82546EB Gigabit Ethernet Controller Specification Update

September 26, 2006

The *82546EB* Gigabit Ethernet Controller may contain design defects or errors known as errata that may cause the product to deviate from published specifications. Current characterized errata are documented in this Specification Update.

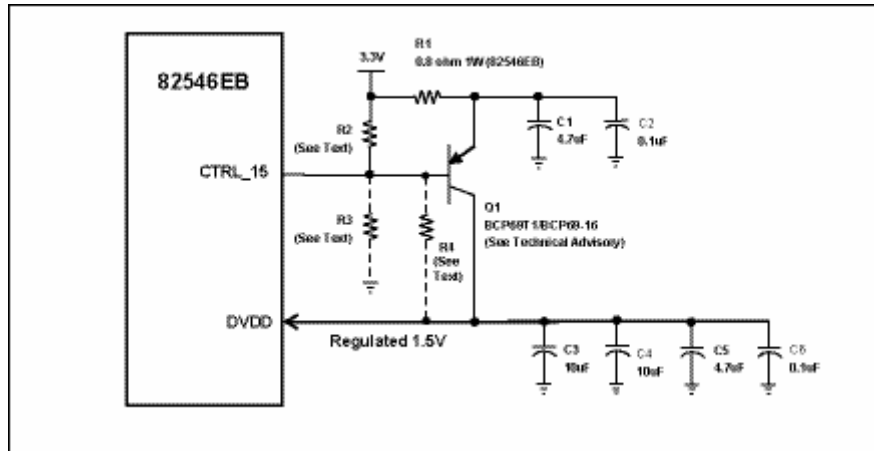
- Problem:** The 82546EB products contain on-chip LDO voltage regulation controllers for both 1.5V and 2.5V. The 1.5V regulator control output, CTRL_15, sometimes powers up in a high impedance state due to a digital portion of the feedback-control circuit which requires 1.5V to be present to operate correctly. The rate of occurrence of this problem may appear to vary from device to device or with different PNP transistors.

- Implication:** When drive is absent on the CTRL_15 output, only leakage current from the CTRL_15 output will be present. Depending on the amount of leakage current and the gain (Beta) of the external PNP transistor, there may be insufficient collector current ($I_C = I_B * \text{Beta}$) to adequately supply the 1.5V rail, and the 1.5V regulator circuit may not turn on. The 1.5V rail requires a minimum collector current of 5 mA to be generated and a 1.5V rail voltage of at least 600 mV to ensure that the digital portion of the circuit turns on correctly.

- When the 1.5V regulator control output fails, the 2.5V regulator control output(s) may also fail, driving the 2.5V supply toward either 0V or the 3.3V rail. The absence of one or both of the 1.5V and/or 2.5V supplies prevents the Ethernet controller from operating correctly.

- Workaround:** The regulator control output is Ball A18 on the 82546EB controller. Intel's original reference designs showed two external resistors, R1 and R2, in this circuit (refer to the following figure)

- The workaround is to completely remove R2 (also shown in the reference schematics as R6 @ 5.1K Ω) and place another resistor, R4, (also shown in the reference schematics as R7 @ 30.1K Ω 1%) to connect between the base of the PNP transistor and the 1.5V VDD output. Existing designs may alternatively use resistor R3 (not shown in the reference schematics) to connect between the CTRL_15 output and ground (refer to the following figure).

- Due to variations in PNP minimum/maximum transistor gain, this circuit must adhere to specific requirements for the PNP transistor, R3 resistor value, and configuration of the 82546EB controller. Follow **workaround instructions** in Technical Advisory TA-149, "Possibility of 1.5 Voltage Regulator Failures on 82546EB LOM Designs." **Note:** Workarounds differ among the 82540EM and 82546EB controllers and each controller has a separate technical advisory.

- Systems that generate 1.5V without using the Ethernet controller's onboard regulator control (at a central power supply, for example) do not need a workaround. No changes are required for the 2.5V regulator circuit.

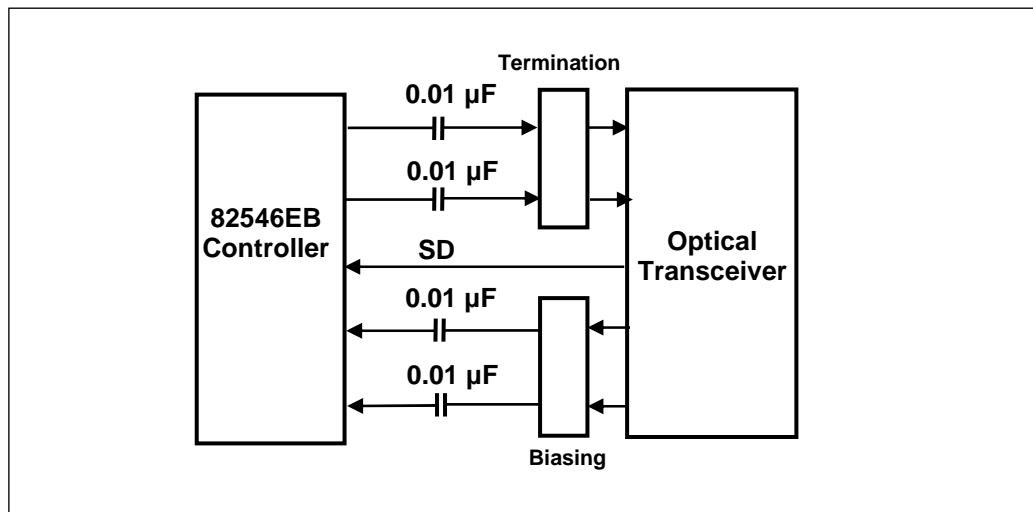
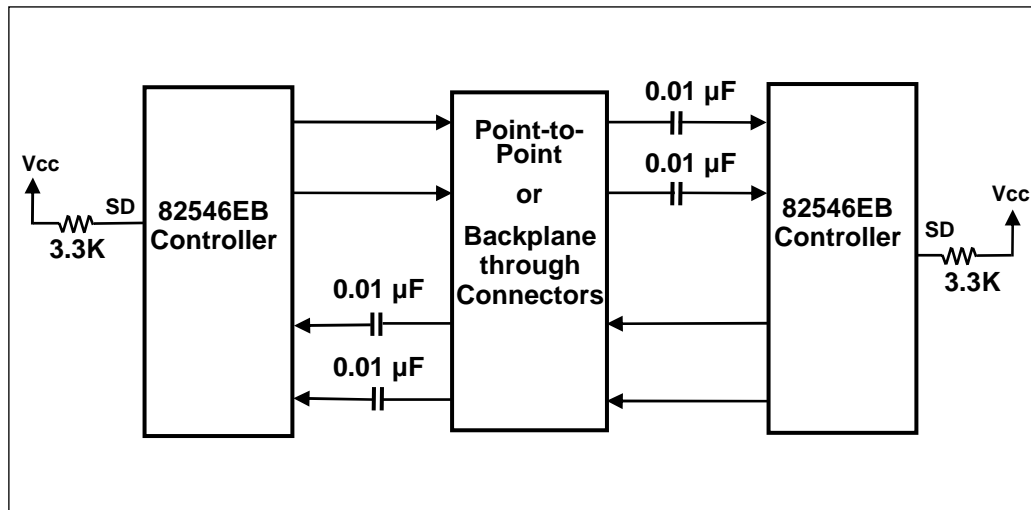
Problem: Intel added new SERDES functions to the 82546EB. SERDES stands for Serializer-Deserializer and is a circuit that converts Ethernet packet data from a parallel TBI format to a 1.25 GHz bidirectional serial stream. For 1000BASE-SX or 1000BASE-LX fiber applications, SERDES integration typically saves the designer the expense and board space of a 64-lead external device. The 82546EB Controller contains two integrated SERDES units and the 82545EM Controller contains one SERDES. A '10' needs to be written in ICW3 bits 1 and 0, respectively, in order to enable this feature.

The datasheet for the 82546EB Controller will change to define pins as follows:

The SERDES ball locations for the 82546EB device are as follows:

RXA +	G19
RXA -	G20
RXB +	J19
RXB -	J20
TXA +	F19
TXA -	F20
TXB +	K19
TXB -	K20
SIG_DETECT A	E20
SIG_DETECT B	L20

82546EB fiber-based applications will use the SERDES interface to drive a 1000BASE-SX or 1000BASE-LX optical transceiver as illustrated in the following figure. The 82546EB controller is internally terminated, so no external termination is required.

Alternatively, the 82546EB controller may be used in short haul gigabit backplane data applications without transceivers and optical fibers. No special termination is required because the 82546EB device is internally terminated. The figure below illustrates a gigabit backplane or point-to-point circuit based on the 82546EB device:

How to Reduce the Case to Ambient Thermal Resistance, θ_{CA} , for LOM Designs

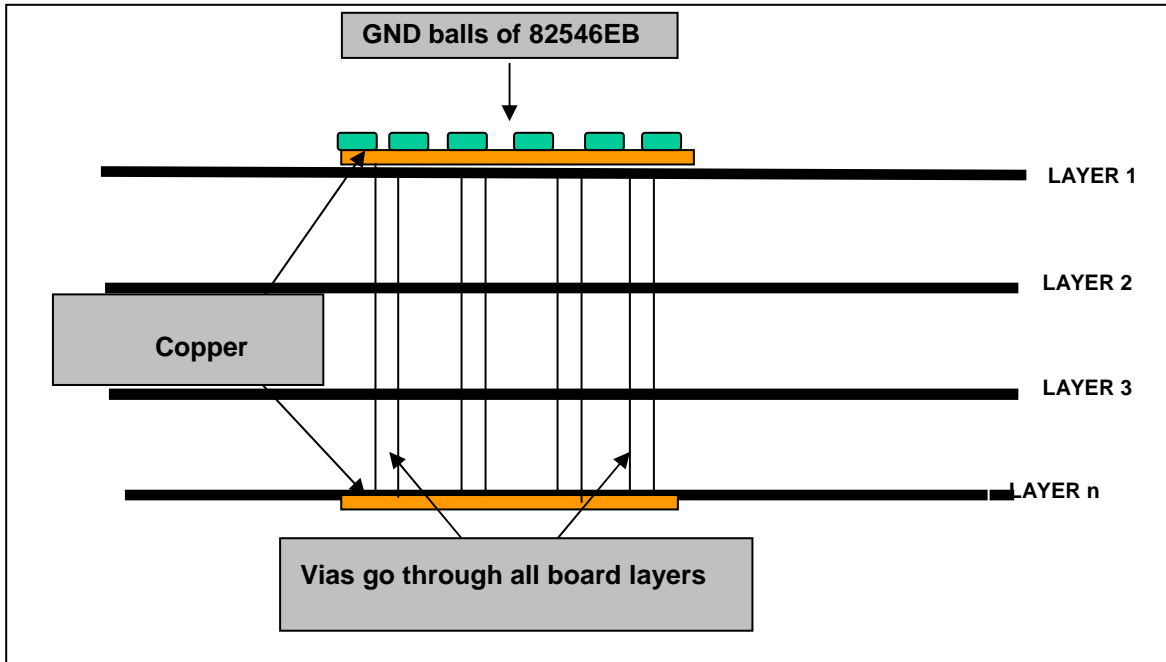
One element that designers can influence in their designs is the thermal resistance θ_{CA} . If increased airflow is not an option, the thermal resistance can be reduced by adding a heat sink to your 82546EB Controller PCB design. The manufacturers of add-on heat sinks should provide detailed literature and technical reports on improvements in θ_{CA} with their products.

An alternative is build a heat sink into the printed circuit board. This is can be accomplished by adding copper to the board and drilling numerous thermal vias for heat dissipation under the BGA package.

Since the GND balls on the 82546EB controller are clustered together, it is fairly easy to use the following layout technique:

- 1) On the first layer of the board, create a copper plane shape under the GND balls of the device. This will create a strong GND connection between balls and provide a large target for the thermal vias.

- 2) Drilling at least 4 thermal vias, which are about 14-18 mils in finished hole size, connect them to the plane shape on the first board layer and tie them to the internal ground plane. The vias should go through all board layers. The vias will act as a conduit for heat dissipation. Bury the thermal via tie legs on all plane layers to maximize heat transfer.

- 3) Minimize any interrupted ground plane under the BGA and within 0.5 inch of the edge of the 82546EB controller package. Solid ground planes help to transfer the heat easily to other regions of the PCB. Large cuts in the plane inhibit the transfer of heat which increases the case temperature of the silicon.

- 4) On the bottom layer, add another copper plane for heat dissipation and good grounding.
